650 NORTH SAN PEDRO ROAD FINAL EIR

STATE CLEARINGHOUSE NUMBER: 2004062004

County of Marin | September 30, 2009

## 7 COMMENTS AND RESPONSES

Figure 1.1 (January 2006)

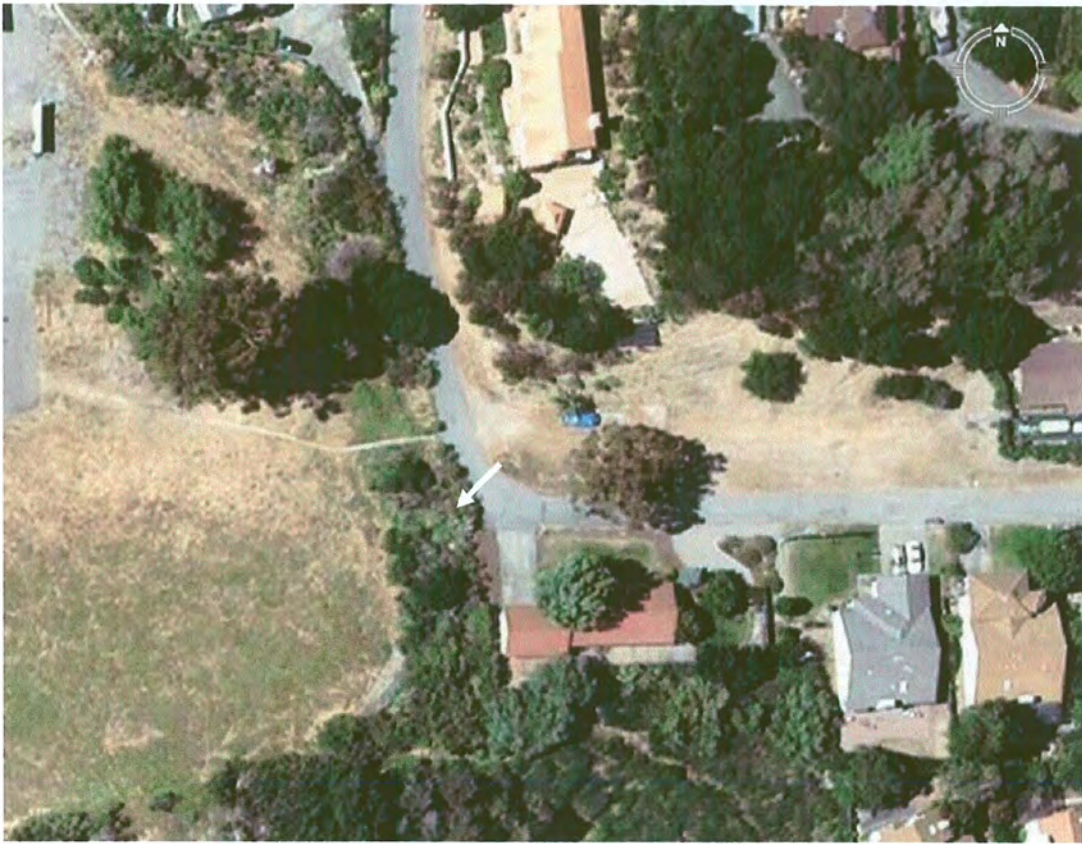
Figure 1.1 and 1.2 (January 2006) show a Marin Sanitary Service truck stuck in the culvert basin.

Figures 1.1, 1.2, 1.4 show that the current flood-control infrastructure from the McPhail School catch/basin to the Gallinas Creek Marsh is entirely inadequate and flooding in this area is directly related to seasonal rains and whims of the highest high tides of the season.

FIGURE 4.3-1  
EXISTING CONDITIONS

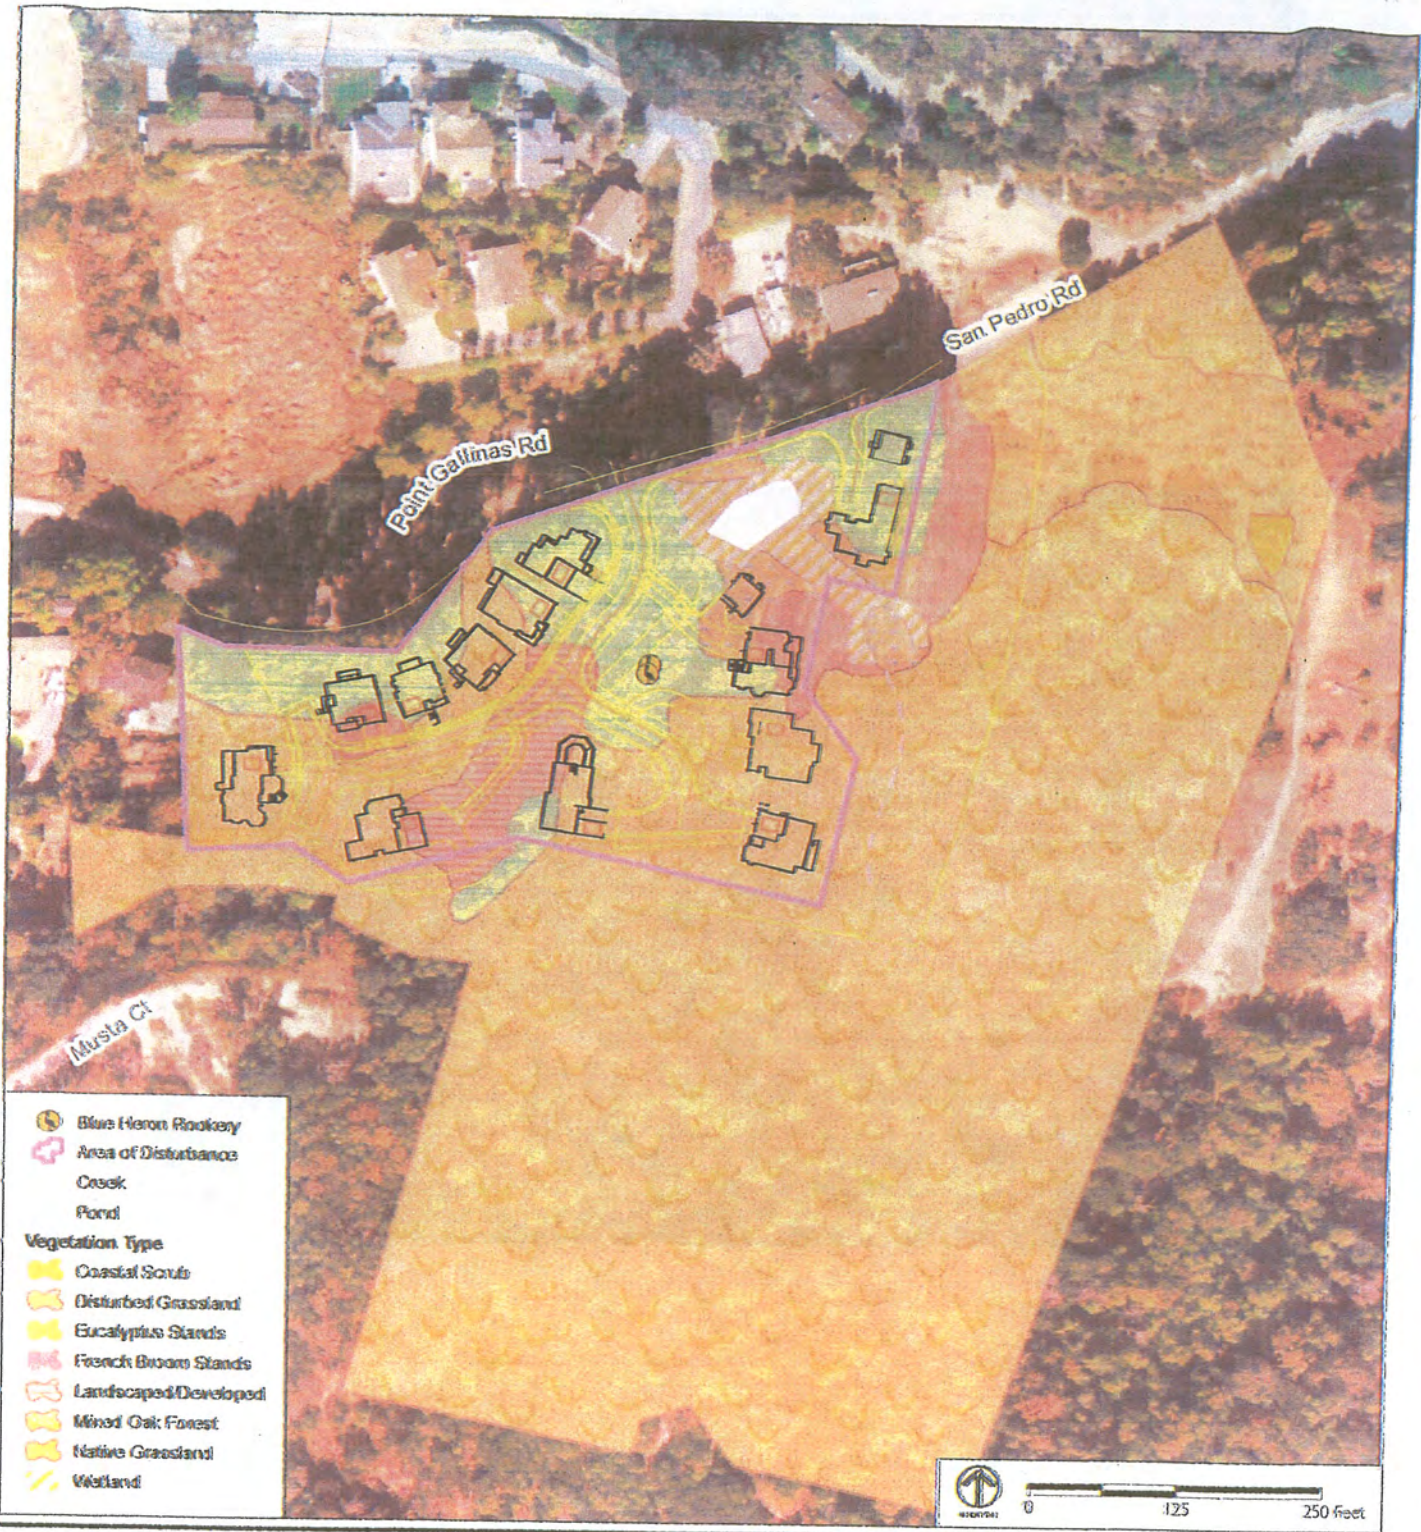
Headlights from vehicles leaving the project site at the proposed roadway entry location would be angled down initially to the NSPR surface and ultimately leveled at the main road. The residences to the north, as can be seen on Figure 4.3-1 of the DEIR, are juxtaposed so as to face away from NSPR. House driveways and garages face the project access road well below NSPR. Furthermore, there is a substantial linear distance (approximately 200 feet) and significant change in elevation (+/- 15 feet of vertical distance) from the entry road proposed and the closest residences to the north. Finally, Figure 4.3-1 also shows that there is a substantial tree mass between the project entry roadway and the residences to the north.

**Figure 3 Elevation - Surface Area - Storage Capacity Curve of Existing Pond**

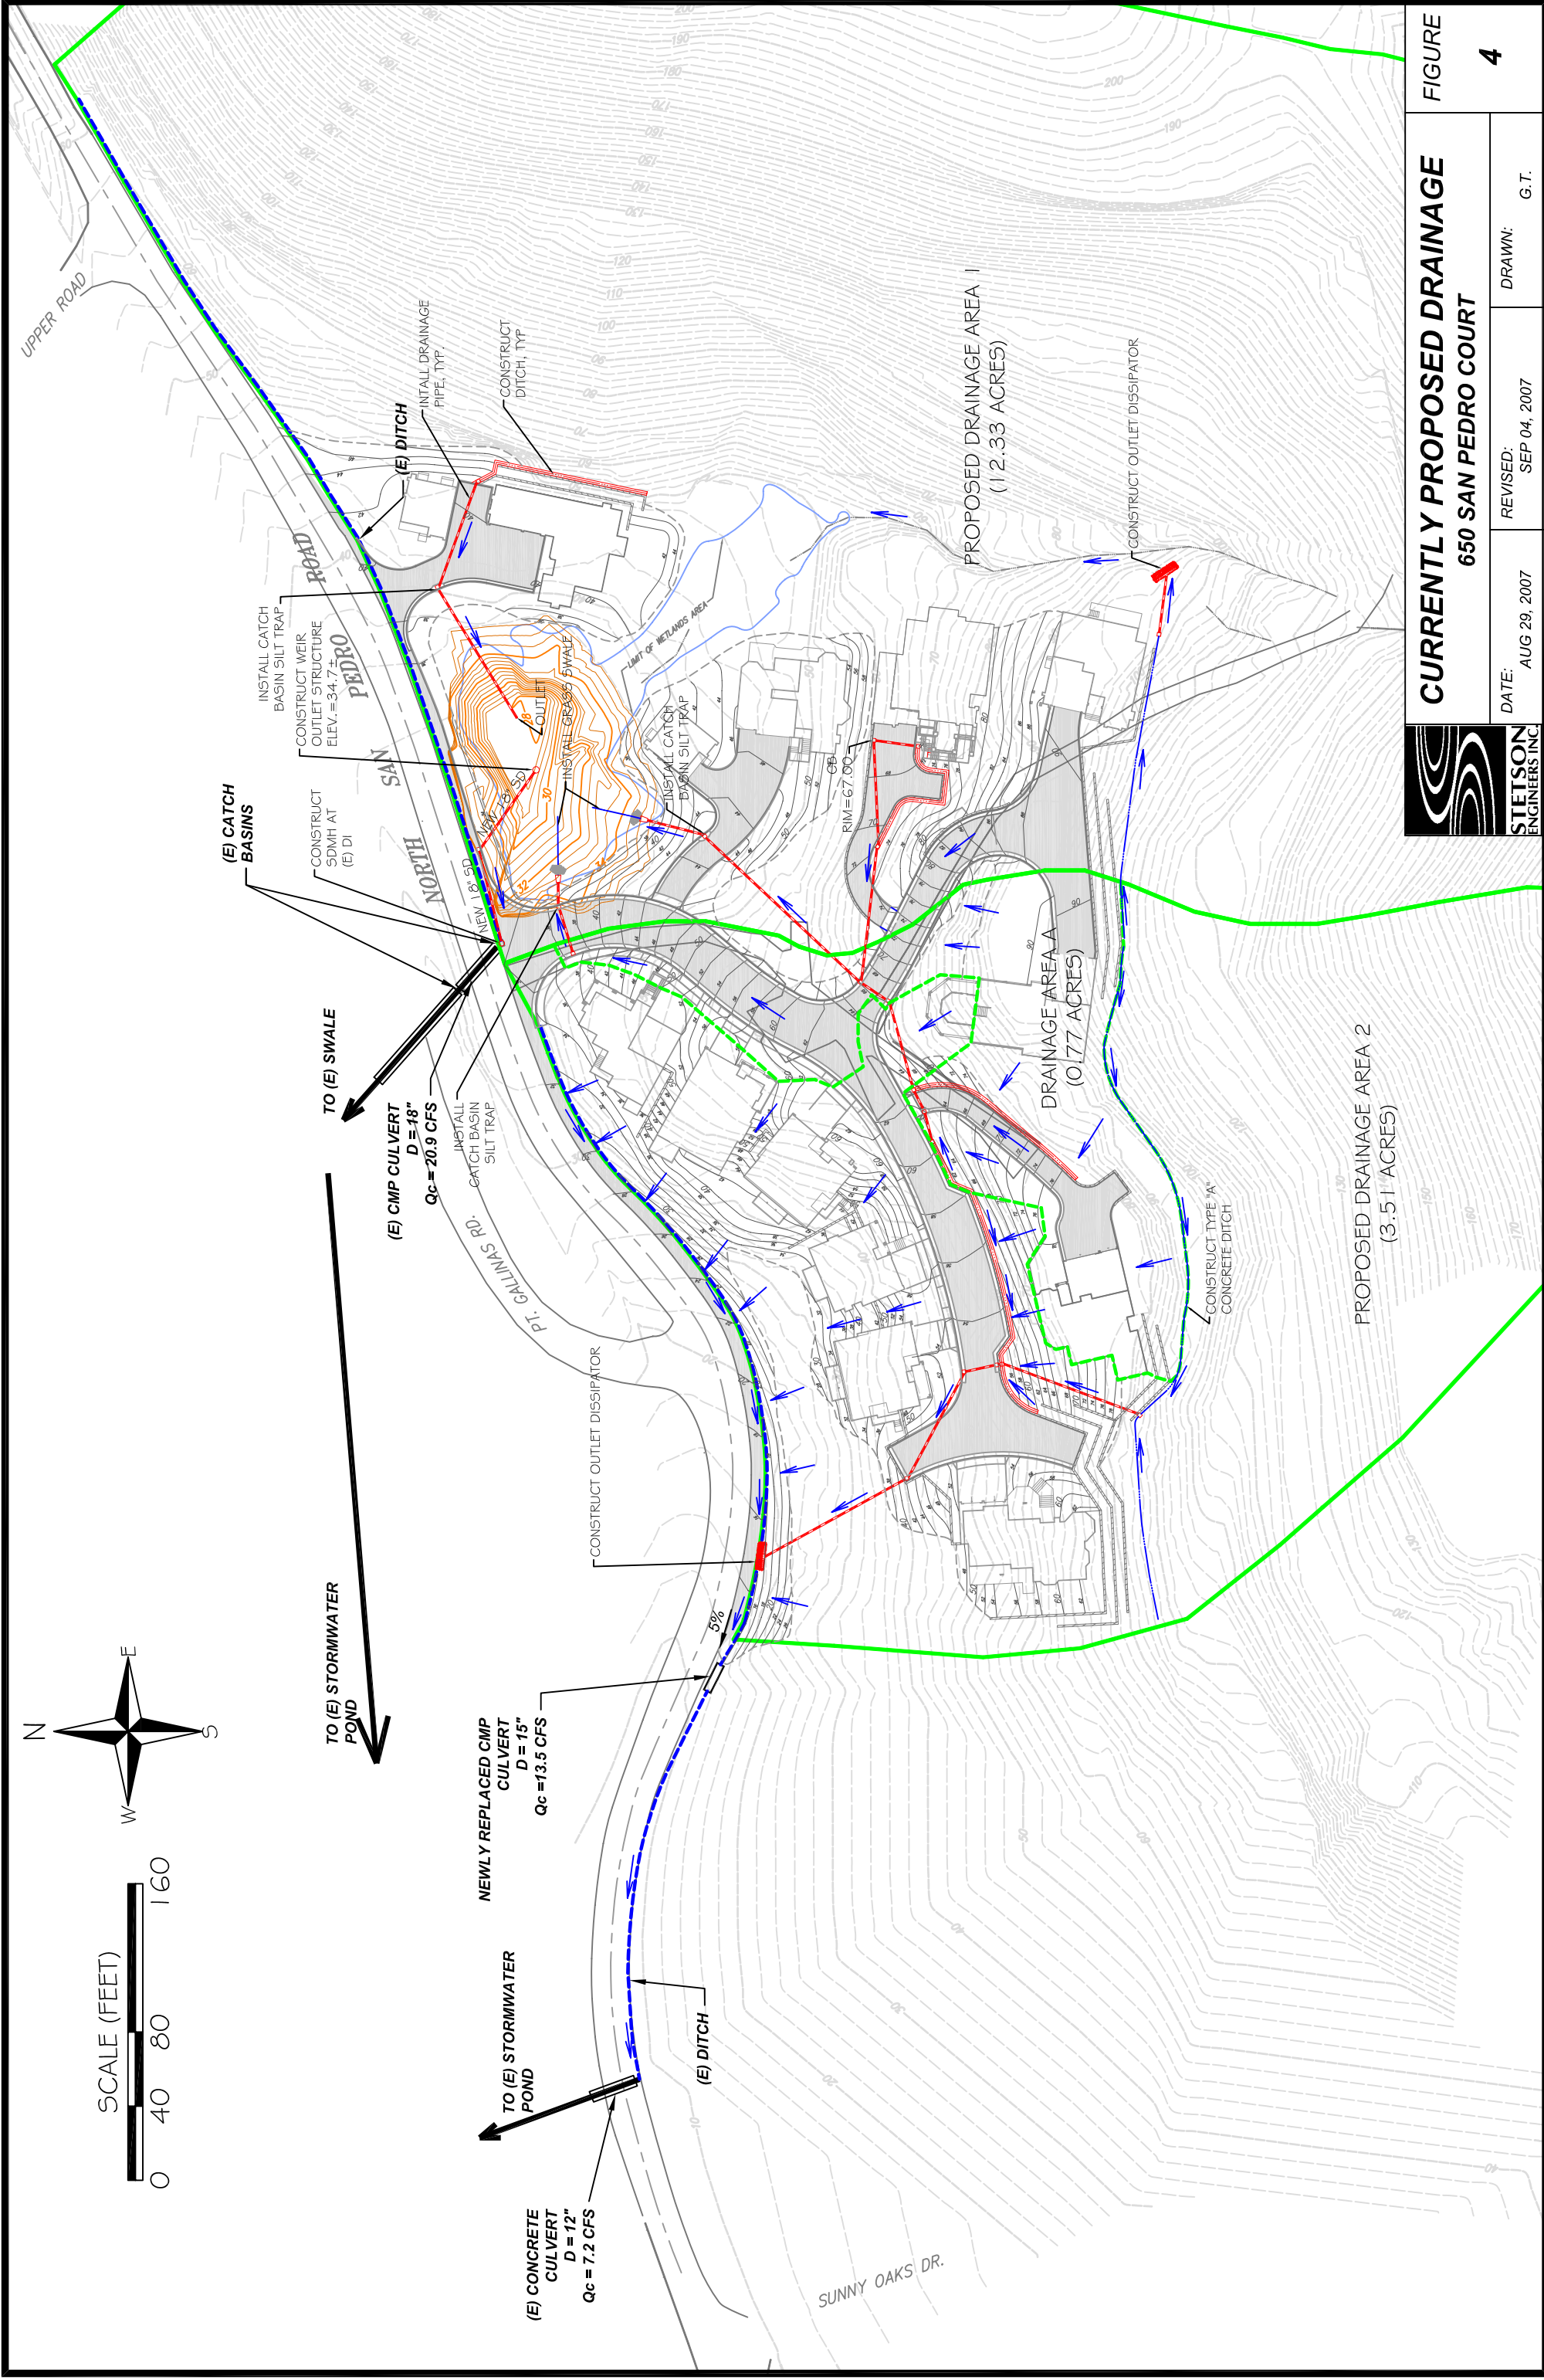
Figure 2 shows the 11.55-acre Drainage Area 1 and the 4.28-acre Drainage Area 2 under existing conditions. Both drainage areas discharge to an existing roadside earthen drainage ditch along the south edge of San Pedro Road. Runoff from Drainage Area 1 collects in the existing pond before discharging to the ditch (Figure 3 shows the storage capacity and surface area curves of the existing pond). All ditch flows are conveyed to a stormwater pond north of San Pedro Road via existing culverts beneath the road. The stormwater pond ultimately discharges to San Pablo Bay via the Sunny Oaks drain/flapgate.

FIGURE 2-1  
VEGETATION AND HABITAT TYPES

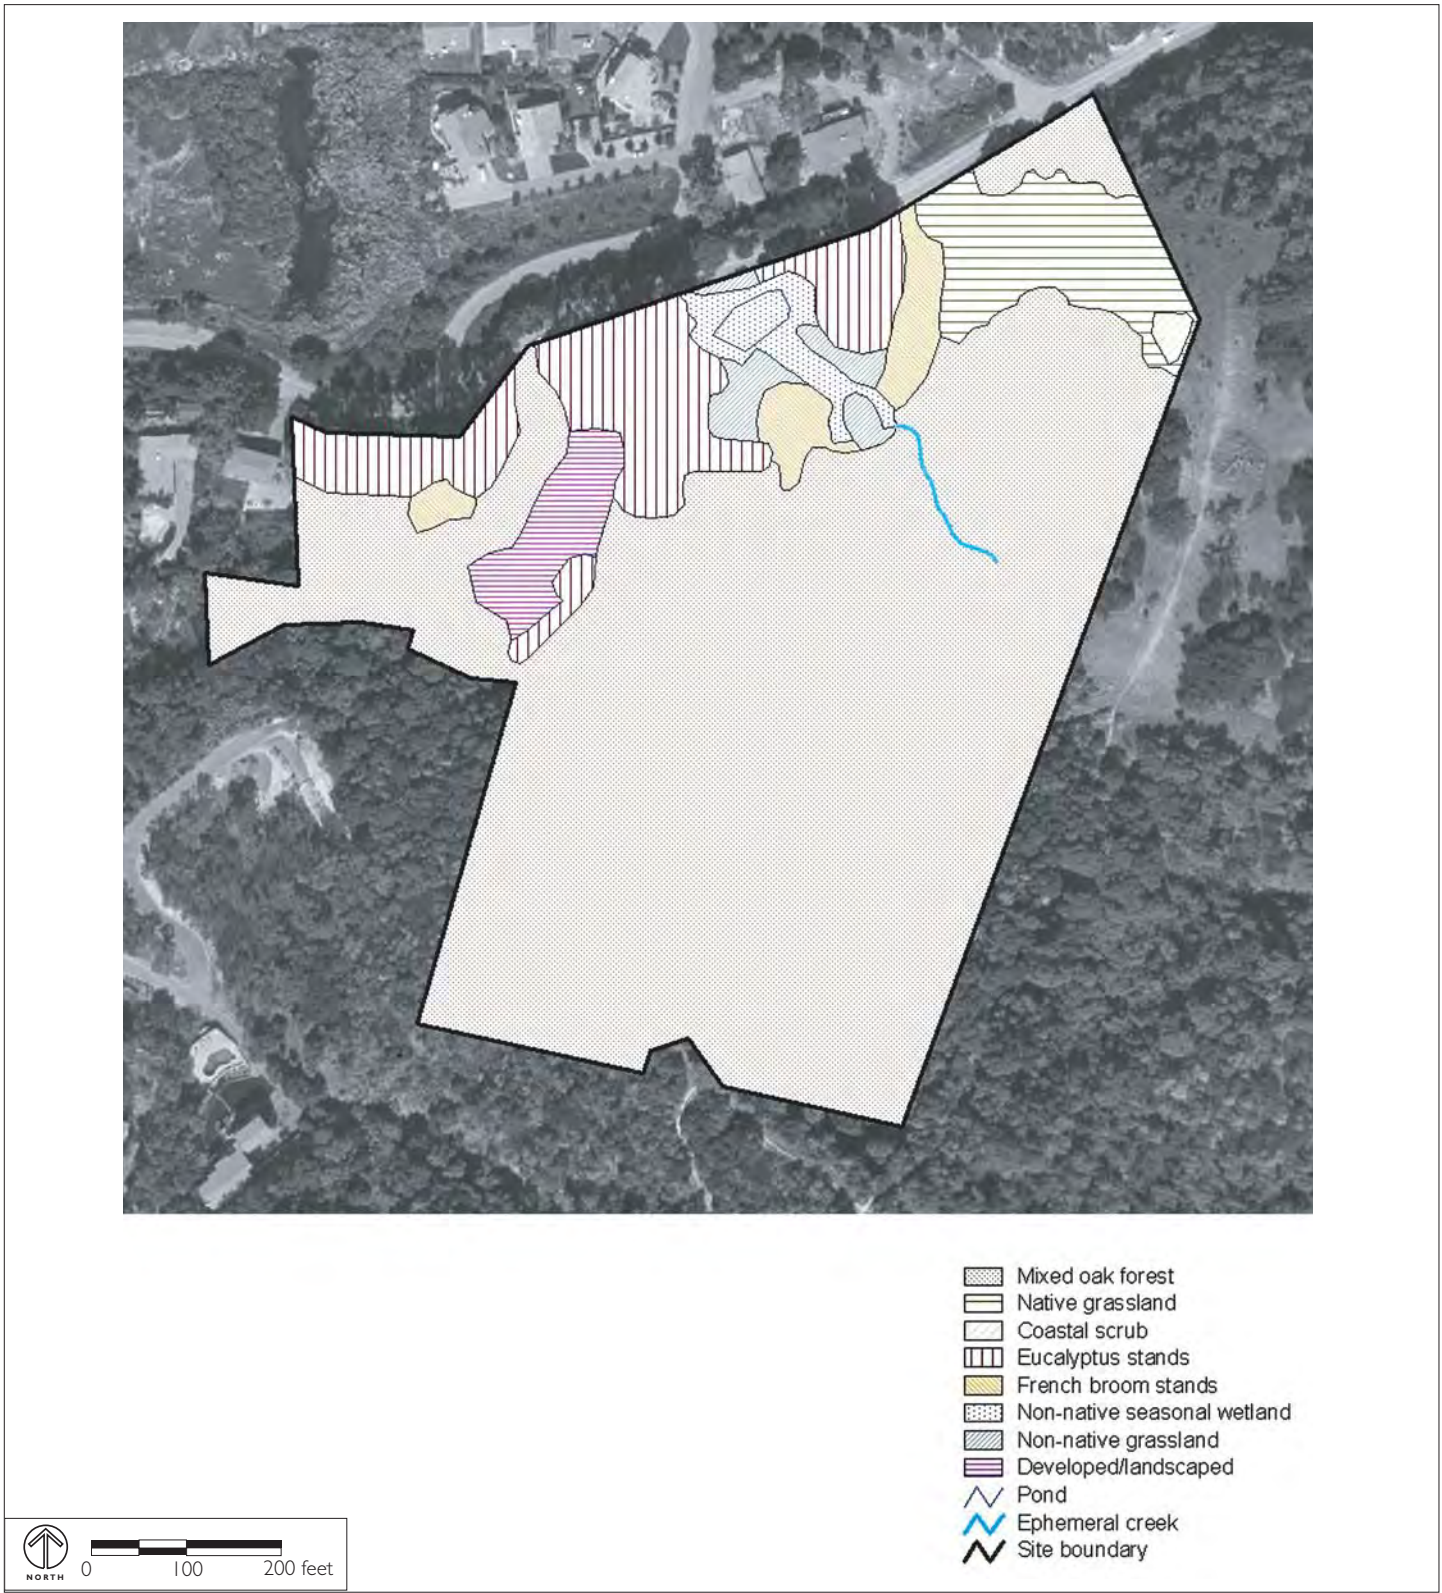
Eight vegetation types were identified on the property. These include three natural vegetation types (mixed oak forest, native grassland, and coastal scrub) and five types that are associated with human activities (eucalyptus stands, French broom stands, non-native seasonal wetland, non-native grassland, and developed/landscaped). Descriptions of these eight vegetation types follow. The approximate extent of each vegetation type is shown in Figure 2-1 and summarized in Table 2-1. Note the Table 2-1 indicates a total acreage of 13.55, though the entire property is much larger. The discrepancy is due to the fact that only the portion of the site proposed for development (13.55 acres) was subject to a detailed field survey and subsequent mapping.

FIGURE 2-2  
SENSITIVE BIOLOGICAL RESOURCES

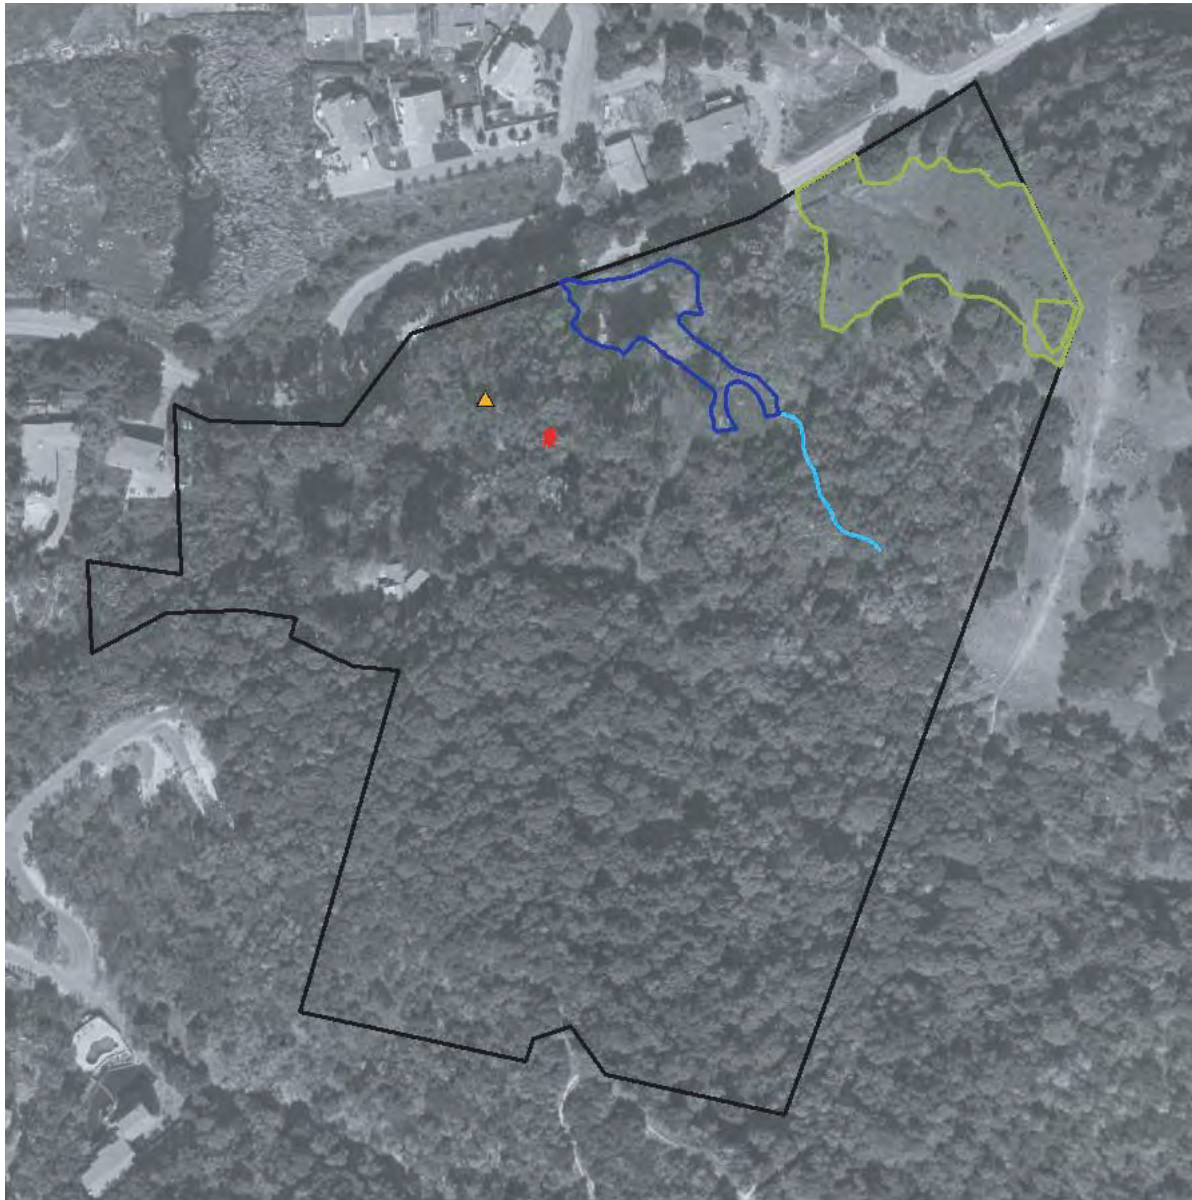
Jurisdictional waters of the U.S. on the project site include the wetland area described in the vegetation section and the ephemeral creek that drains into the wetland (Figure 2-2). The jurisdictional wetland consists of the existing pond, the surrounding pond margin up to the 34-foot elevation contour (as mapped on the Topographic and Boundary Survey [ILS Associates, Inc. 2003a]), and a zone of wetland vegetation that extends upslope from the pond margin to the outlet of the ephemeral creek. The area of this jurisdictional wetland is 0.29 acre.

Two active great blue heron nests were observed on the project site, in a large eucalyptus tree located approximately 200 feet northeast of the existing house on the property (Figure 2-2). Adult herons were observed at the nests during the March 2005 survey, and fledglings were present in both nests in May 2005 (J. Starkweather, pers. comm.). This site provides a favorable nesting location because the nest tree is visually screened and buffered from wind and other sources of disturbance by surrounding tall trees and the slope to the south. This nesting site has been utilized for the past three years (J. Starkweather, pers. comm).
